As-built Baseline Monitoring Report FINAL

Lochill Farm Stream Mitigation Project

Subject: Response to DMS Comments for DRAFT As-Built Baseline Report
Lochill Farm Stream Mitigation Project, Orange County
DMS Project # 97083, DEQ Contract #6828, Neuse-01 River Basin

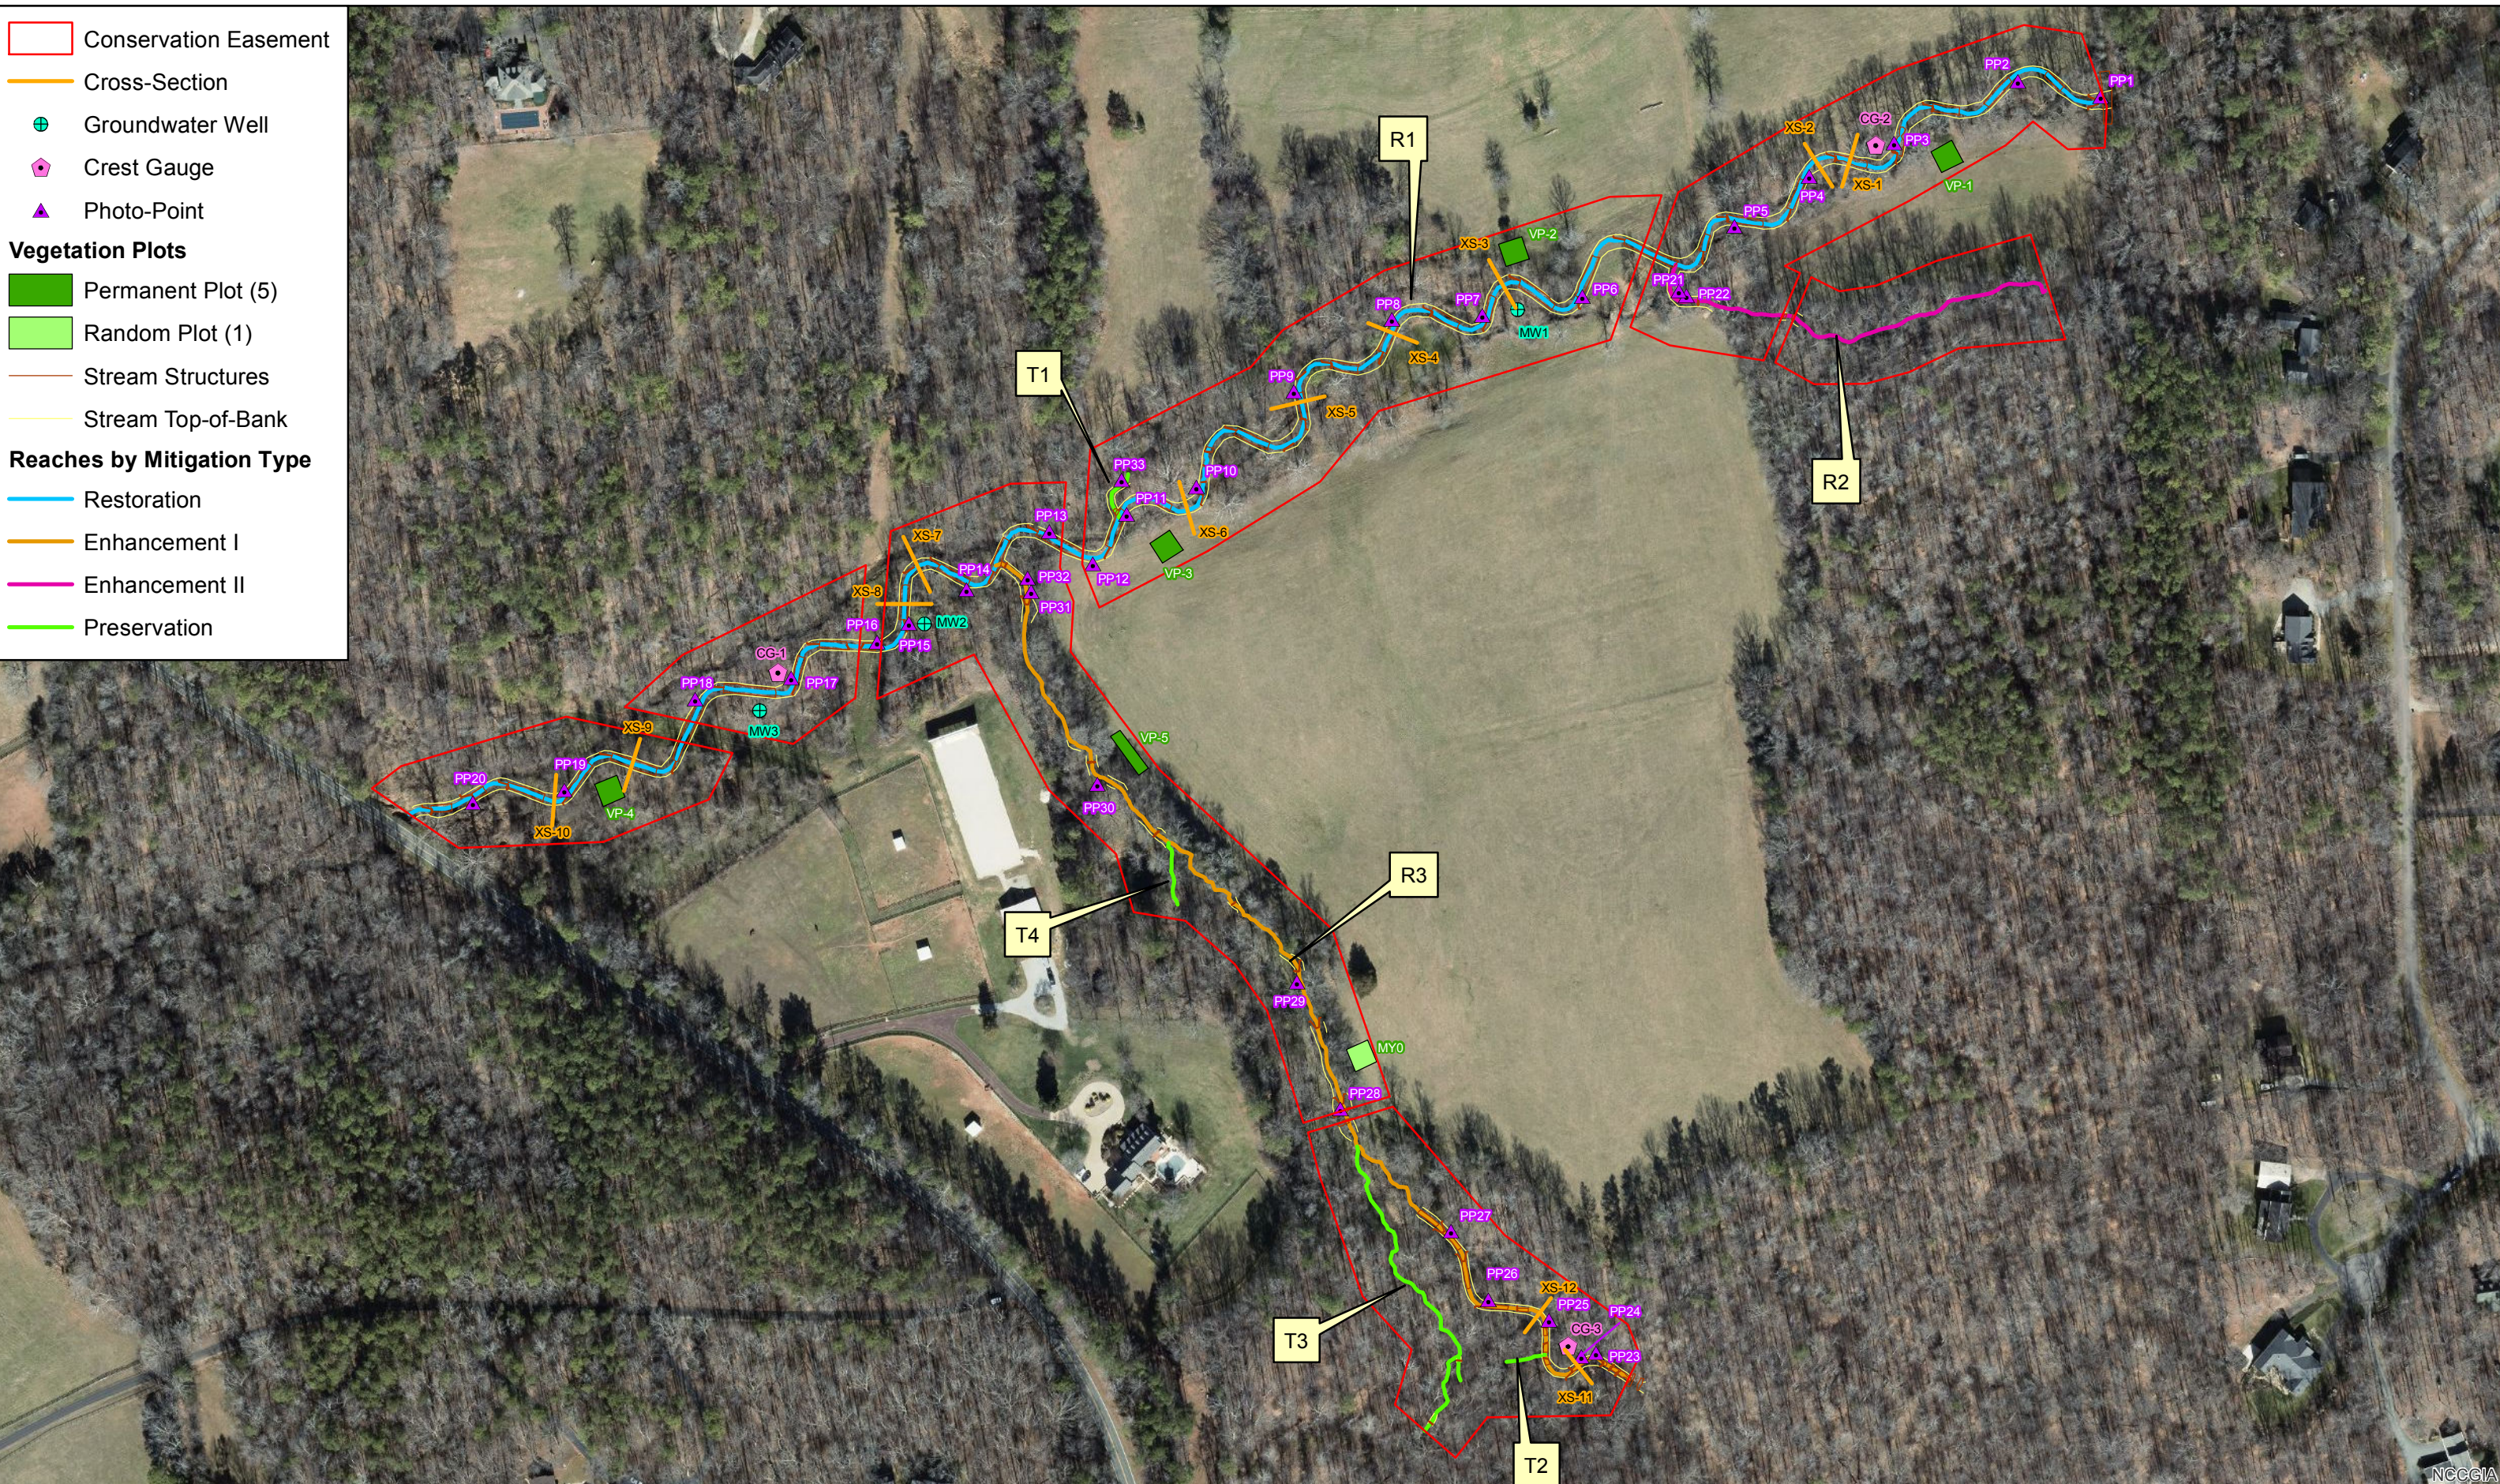
- Add Riparian Buffer asset onto your Figure 2 to show those assets by type. Alternatively, provide a secondary figure for those assets.

Response: A new figure was created to clearly show both the stream and riparian buffer assets on the project.
